**Consumers
Power
Company**

February 20, 1975

Re: Docket 50-255
License DPR-20
Palisades Plant

RESPONSES TO USNRC
Request of February 4, 1975
for Additional Information

'A' STEAM GENERATOR

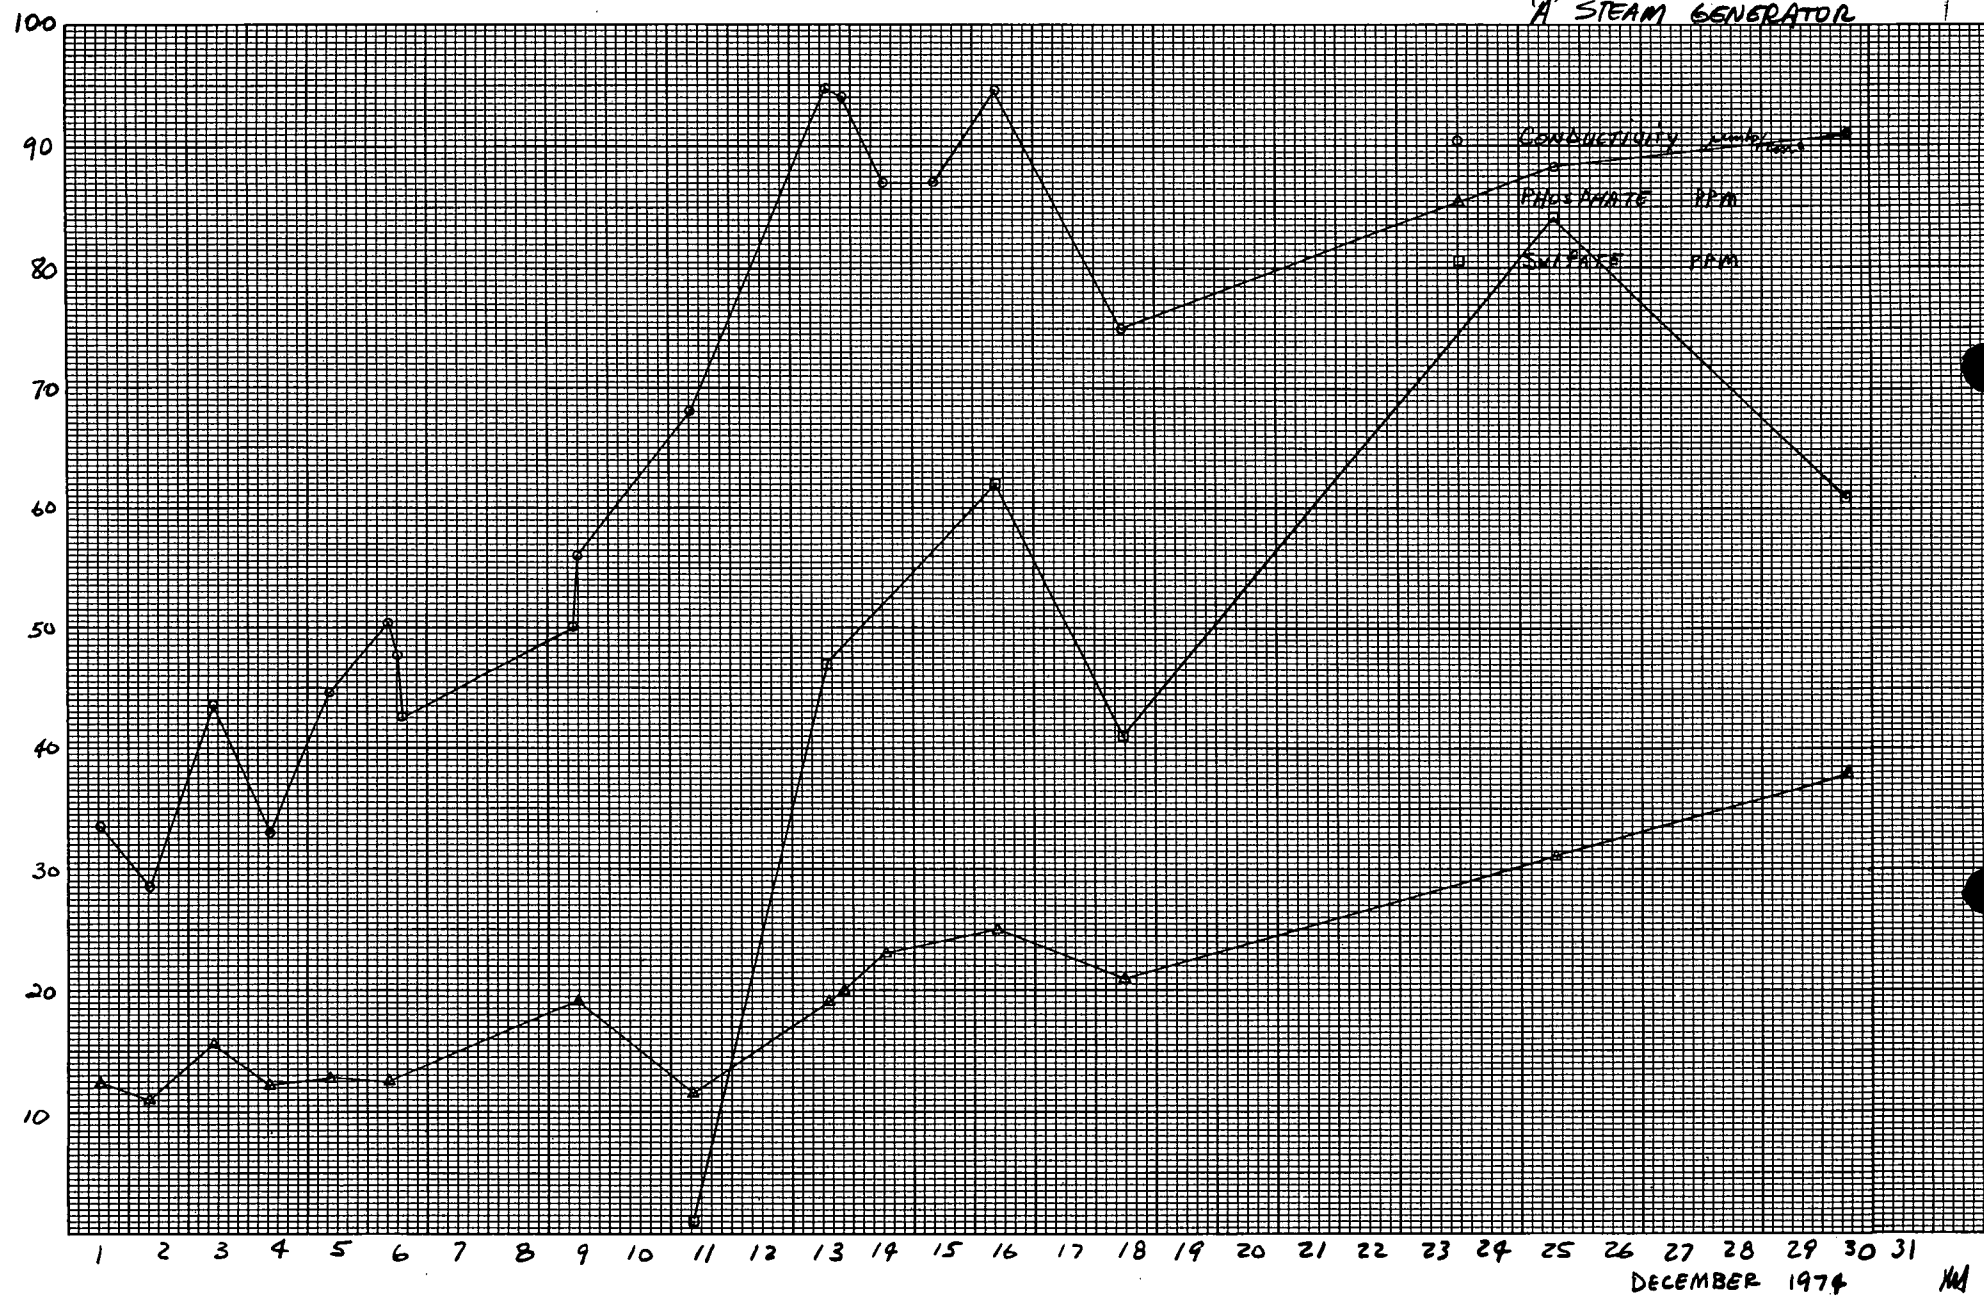
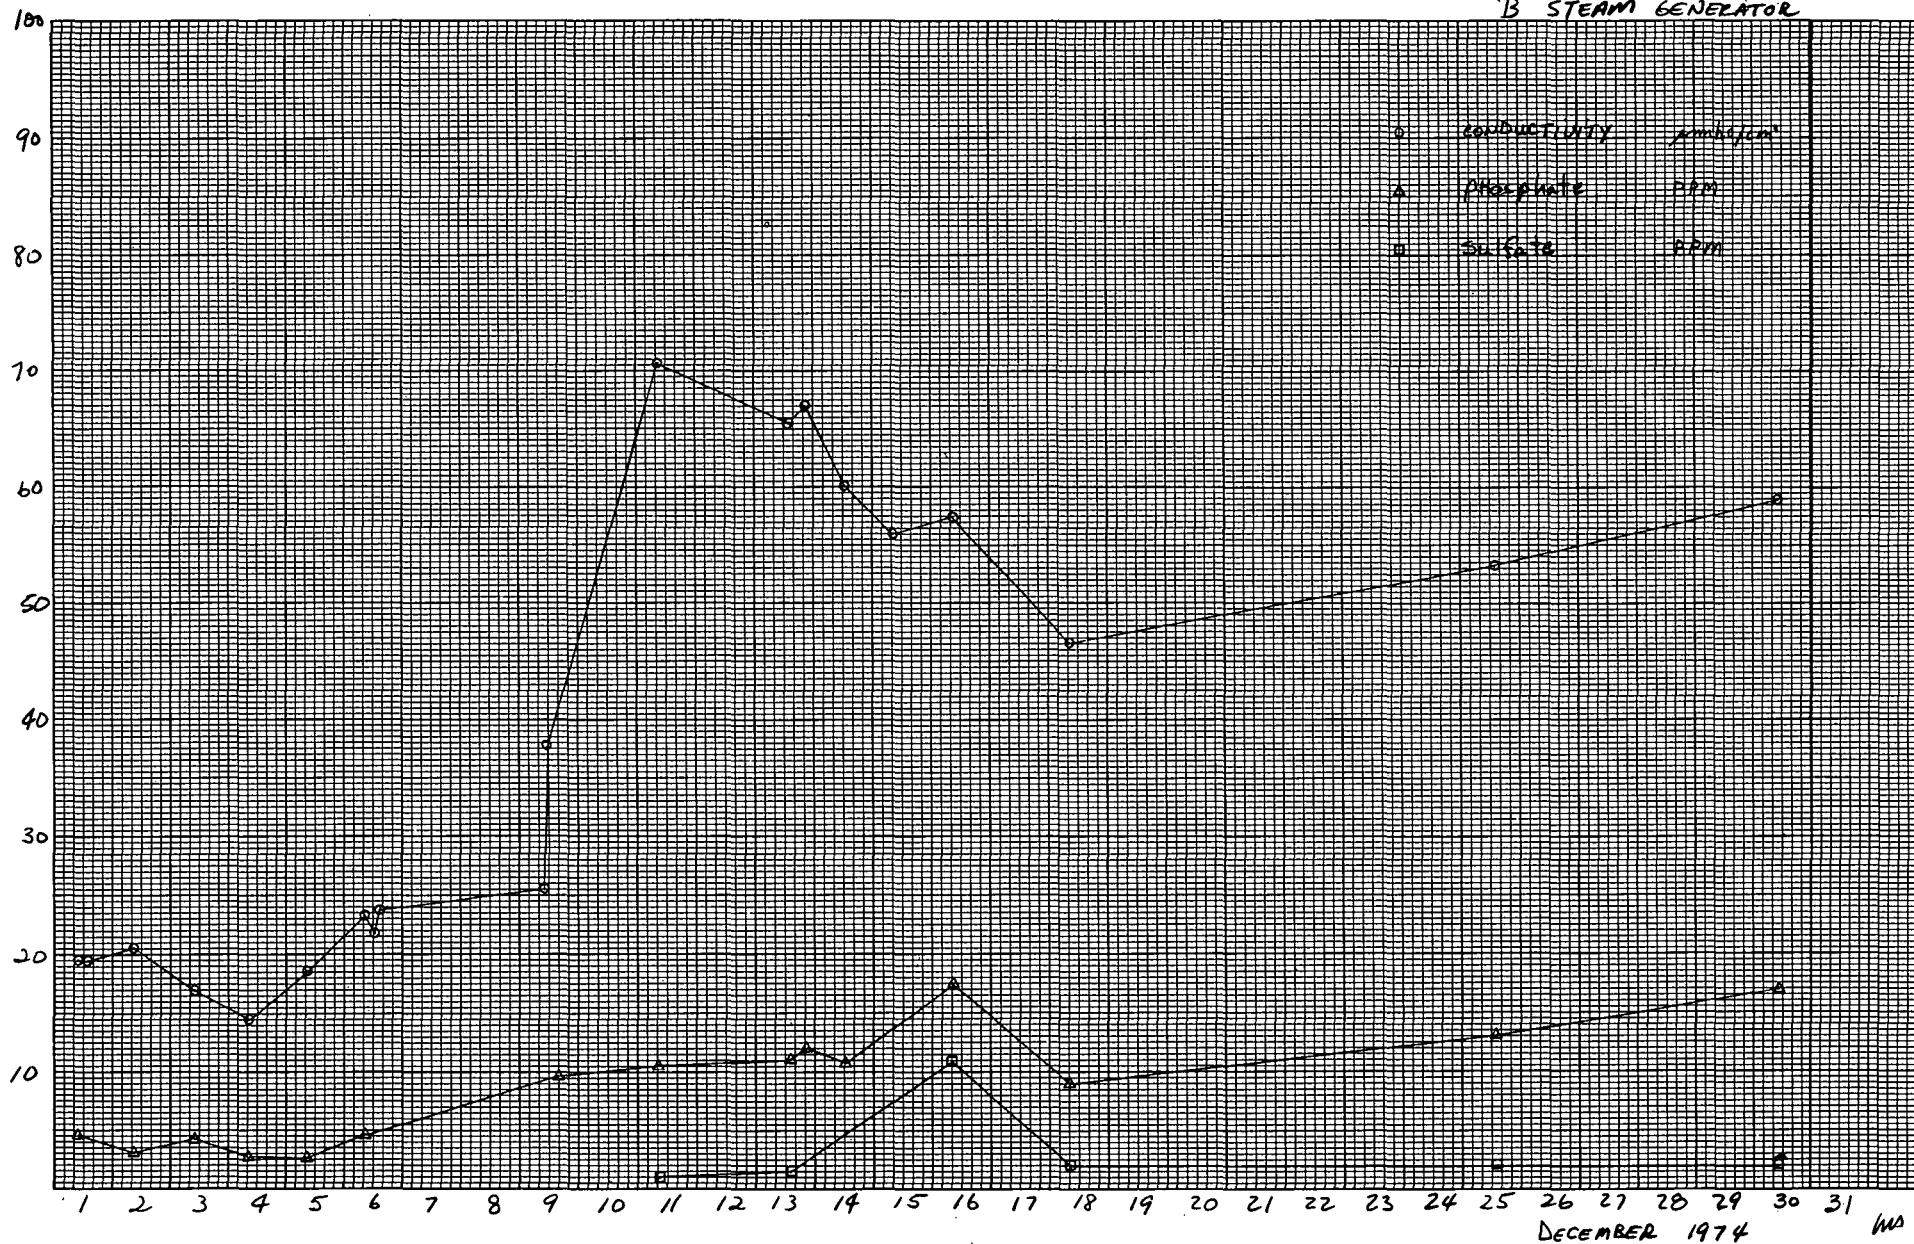
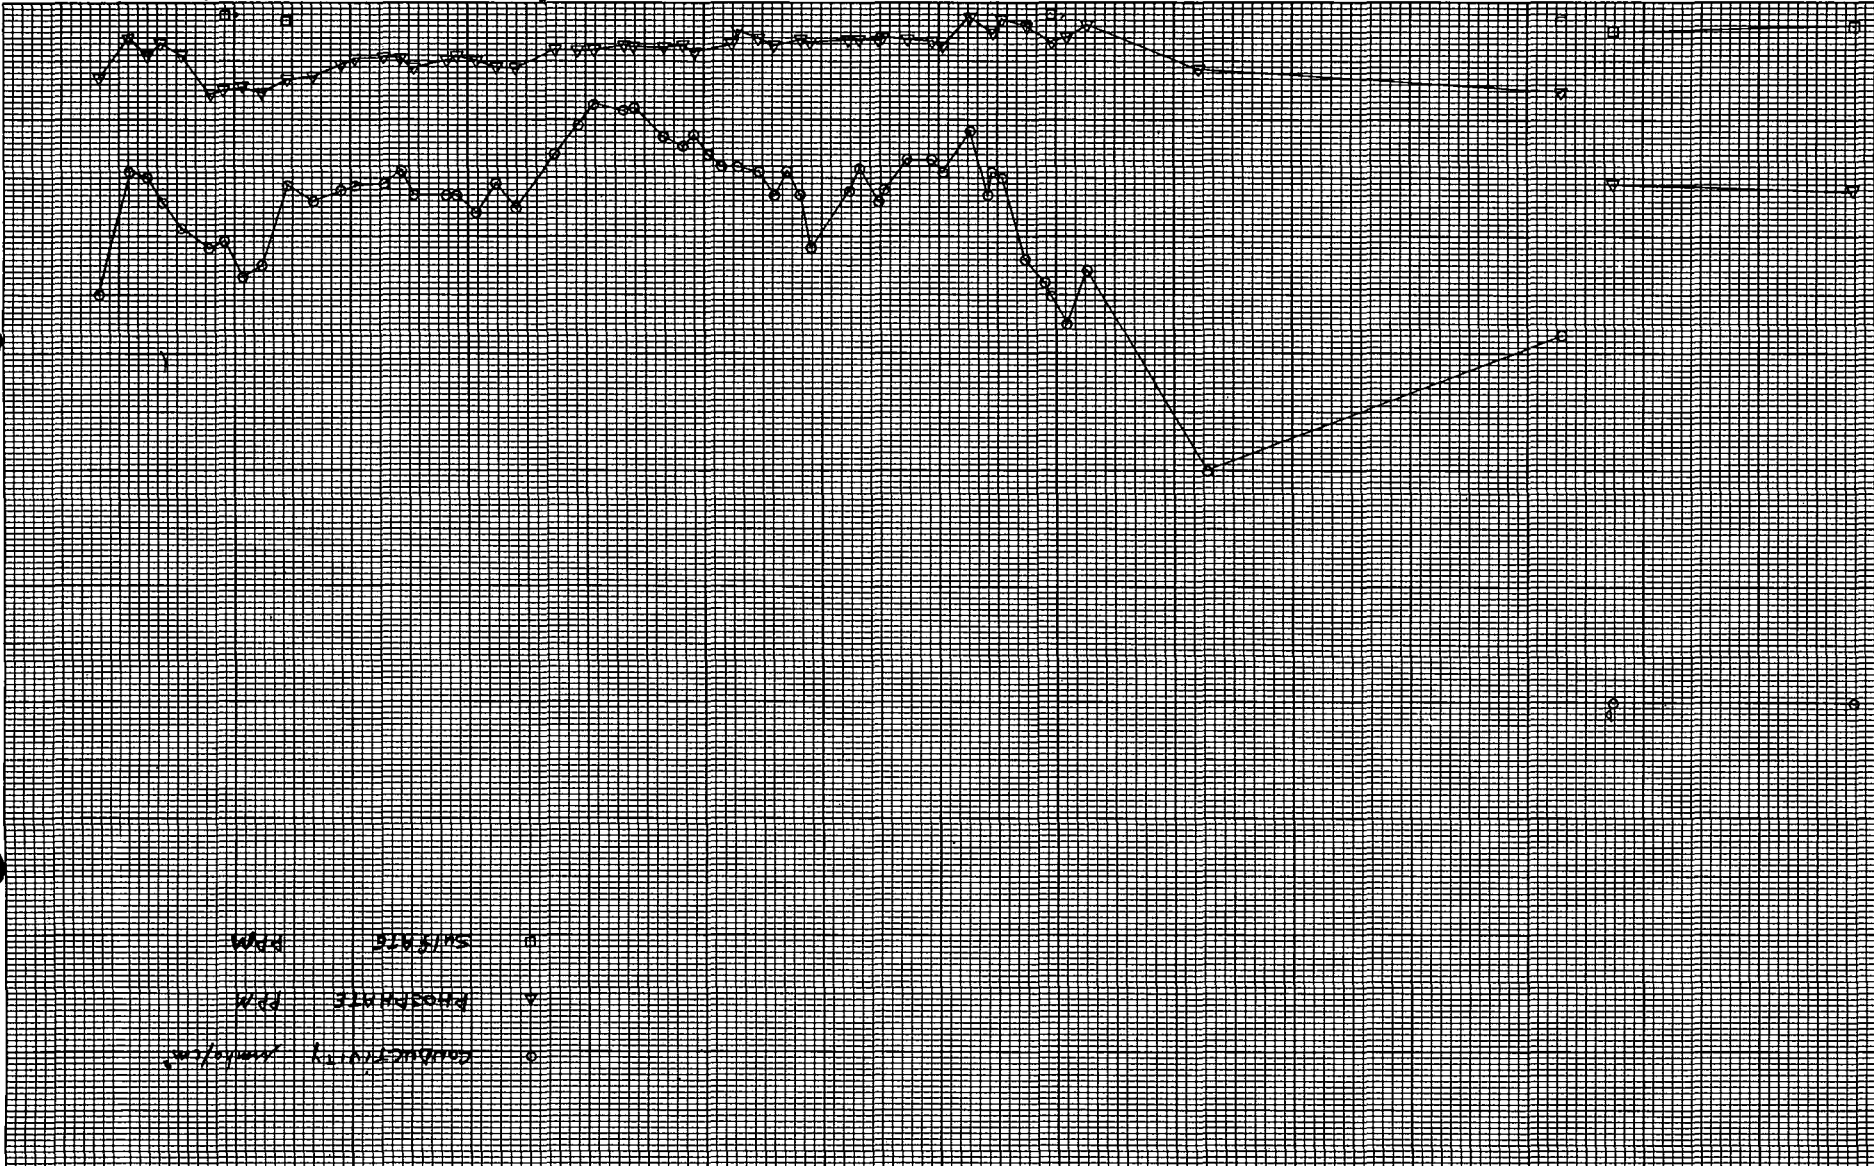
Question 6

"Provide a graph or plot showing the following as a function of time for both steam generators from the onset of isothermal flushing operations to the present:

- a. Phosphate and sulfate concentration,
- b. pH and,
- c. pounds of phosphate and sulfate removed.

The attached graphs, supplemented by the notes listed below, are provided in response to this request.

Notes

1. The letter "D" on several of the graphs indicates a sample (generally a composite) taken during a generator drain.

2. The first accounting of total PO_4 and SO_4 removed from the generators took place in early September; however, due to the error noted late in September with the PO_4 analysis, the total PO_4 removed starts in October. Quite a lot of work would be required to go back and add up the results for the missing four data points (September) and, therefore, it was not done.

3. Due to circulating water leakage (high in SO_4) after October 1, 1974, the pounds of sulfate removed from the generators were no longer calculated. It would be impossible to determine whether we are removing sulfate from the "old sludge" or from the "new sludge" caused by condenser leakage.
